RFQ- Internet Service Provider- Pre-Bid Meeting(PBM) Queries and Answers
Date & Time : 02 January 2019, 4:00PM - 5:00PM

Proposed Network

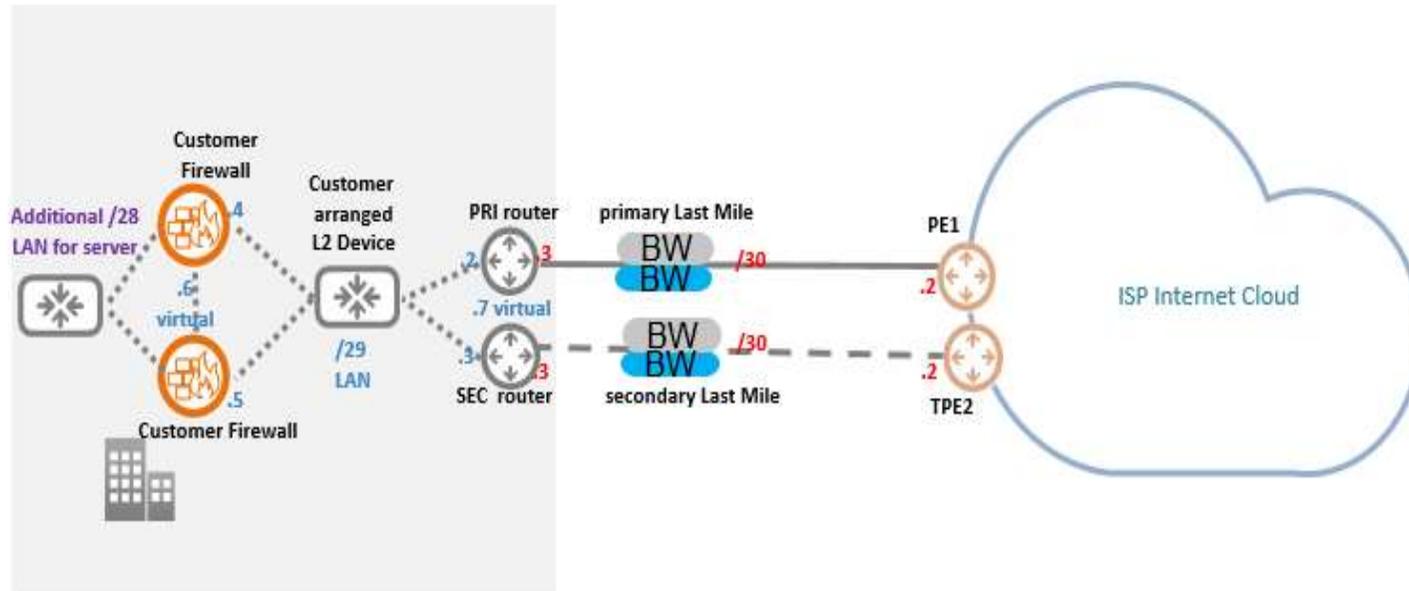
18	ISP	5	ISP shall provide dual last mile and the proof of 2 last mile wired providers for redundancy purpose	Tata Communications proposes Dual CPE, Dual LM and Dual PE setup. Customer to confirm if the approach is ok. Customer to confirm if this will be Active/active or Active/Passive links	Approach is correctly mentioned. We need redundancy in solution with dual last mile, dual router, dual POP, dual CPE. ISP shall provide proof on last mile path redundancy We need active/ passive link solution.
